# Public Meeting Summary

Individual Environmental Reports 1, 2 and 3  
Feb. 28, 2008

St. Charles Parish, IER 1

# West Return Floodwall

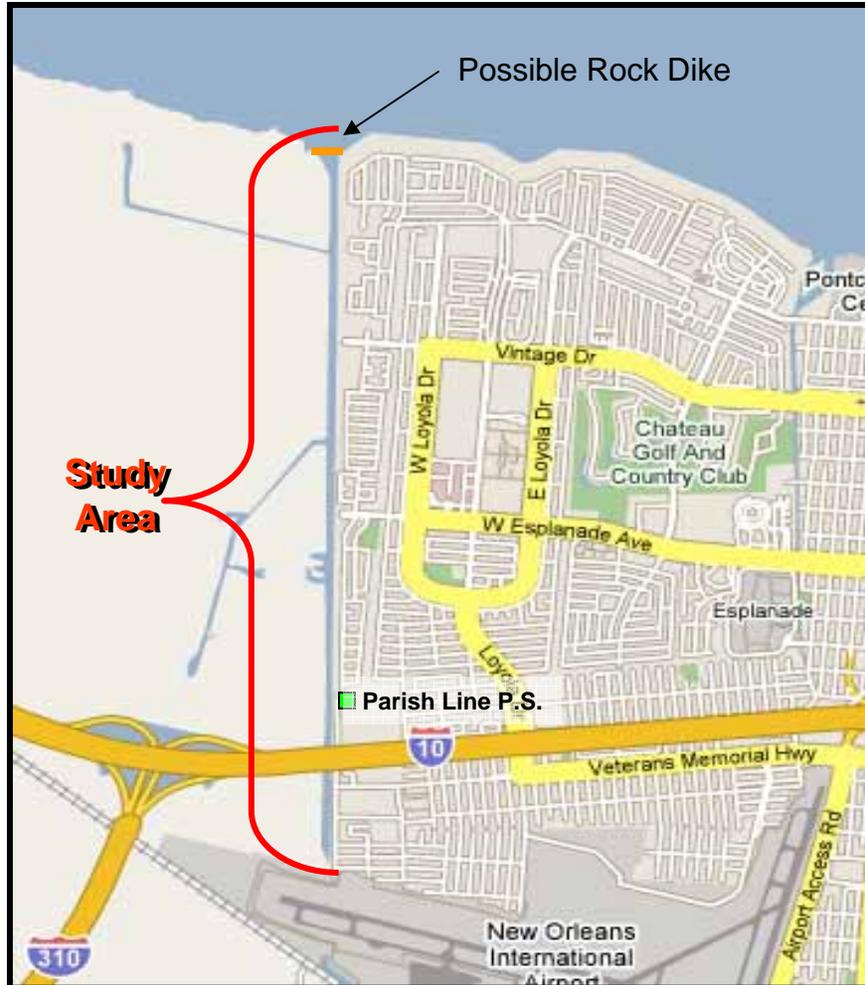
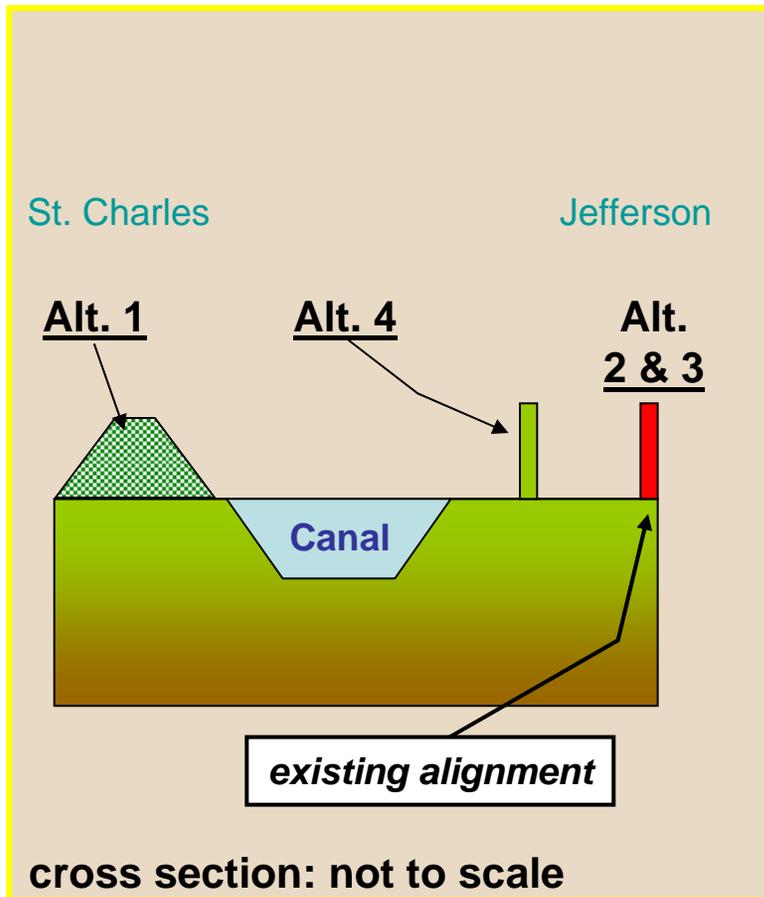
**Question 3.** Ryan Craigs, West Return Canal: I understand alternative 4 is what you'd like to do. The problem with alternative 4 is when you have a tidal surge of 11-14 feet with 110 mile winds hitting a wall; it will just shake my house to pieces. What you are doing here is putting up another parallel wall. I want to see something to stop the impact it will have against that wall. Using borrow along the wall and making a slope, even though it's a steep slope, would be good for recreation and letting waves break on the levee rather than slamming into a wall.

Alternative 1 on the west of the canal would break there and not on the wall. If you have to put borrow on the east, why not the west where people could recreate?

**Question 5.** Jim Martin, Metairie: In alternative 4, what would happen to the existing floodwall and if it remains? How will you drain it?

**Response 3.** Waits: You're talking about the levee on the west side. The soil foundation and technical solution is being taken into consideration.

**Waits:** We looked at a T-wall at 35 feet. A T-wall on piles or steel high beams at certain depths is what engineers say is the foundation needed [inaudible] global stability and is weak so the potential for failure is great in that scenario. That's what brought us back to this side of the canal with [inaudible] if I pile dirt I may have the same situation and have to worry about failure. To combat failure we would have to build a berm on either side of the levee. We would need a wider footprint. We looked at building a levee but then I'd need 400-500 feet of berms so we eliminated it because that drives the cost up because it's in neighborhoods.

**Response 5.** Waits: That's a major concern. The existing wall would be torn down to add in fill and extend the property out there to maintain drainage.

# Typical Fronting Protection Jefferson Parish Horizontal Pumps

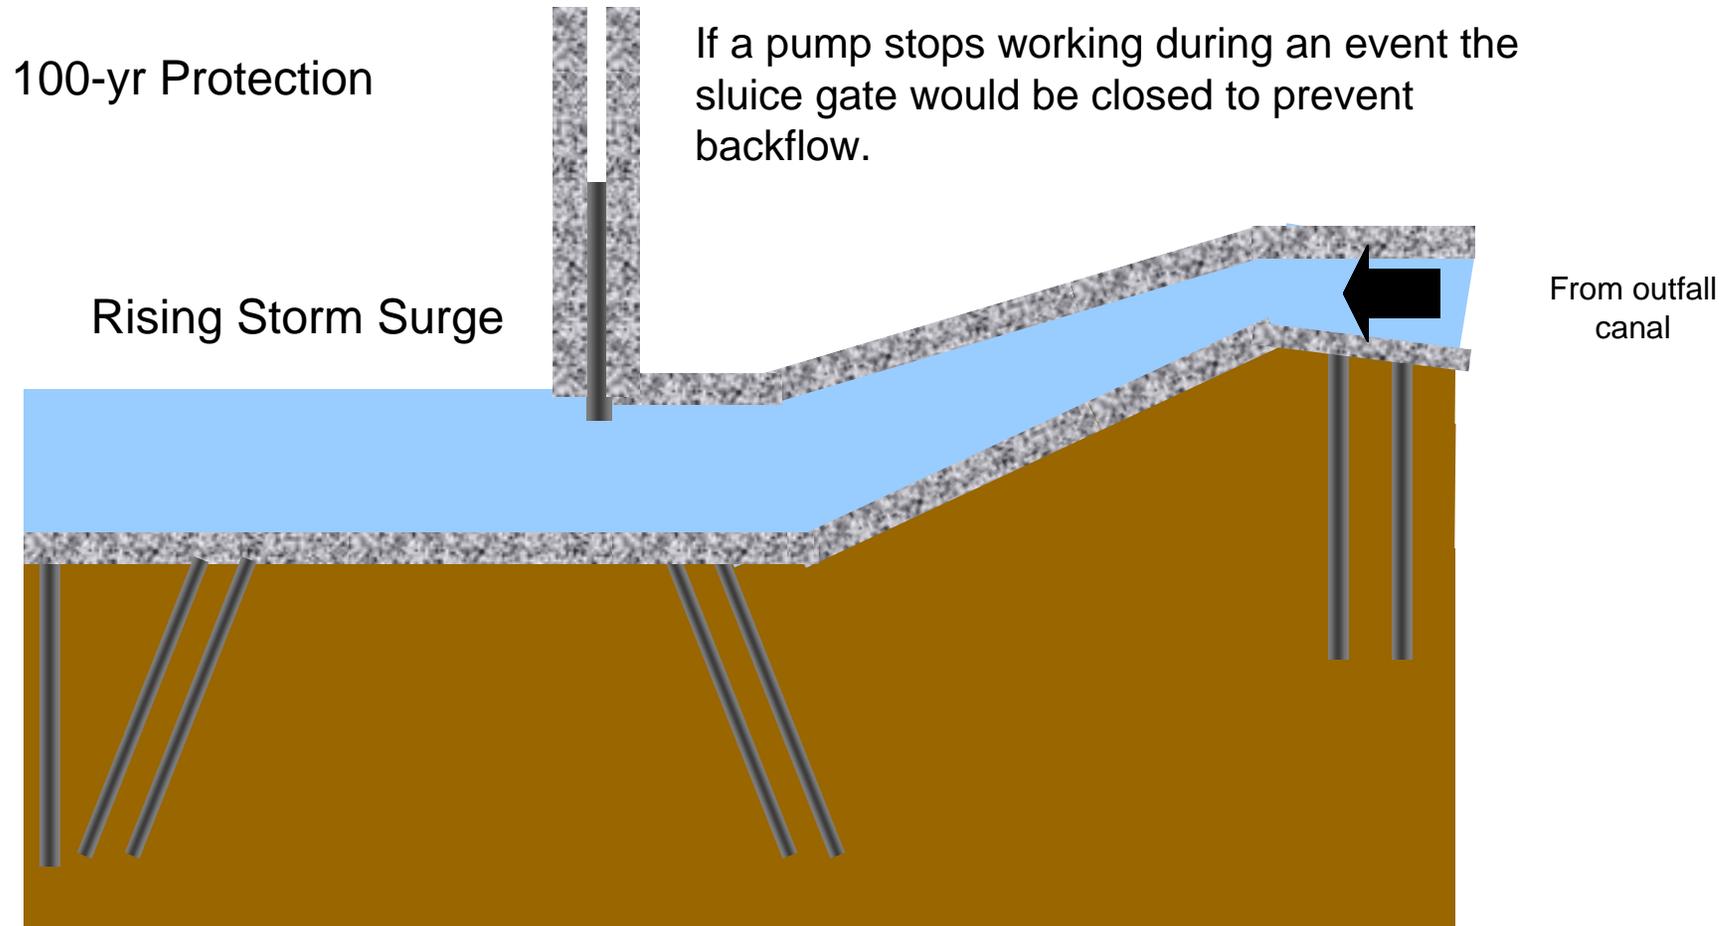
**Question 2.** Rudy Newbeck: My question is about page 18 and 19 of the handouts, typical fronting protection. That is the current configuration without backflow? These are not going to be [inaudible]. Do they have to be operated by a person?

**Newbeck:** There is no thought to have a passive system that has a self operating valve that would depend on waterflow?

**Newbeck:** What do we have in place right now? Backflow generators didn't do what they are supposed to.

**Newbeck:** It still seems like a weak link. If it's not the best levee system and if it is not stopping backflow, we'll flood again.

**Response 2.** Anderson: They will have motors and they won't have to be manual. They will be automatic.

**Anderson:** You can flip a switch.

**Anderson:** We can flip a switch from the safe house.

**Herr:** The problem with the system is that the pump station operators were evacuated and there was no one to monitor it. With new safe houses, the operators would not need to be evacuated.

**Herr:** The best solution is positive cut off which will be in place with a contract.
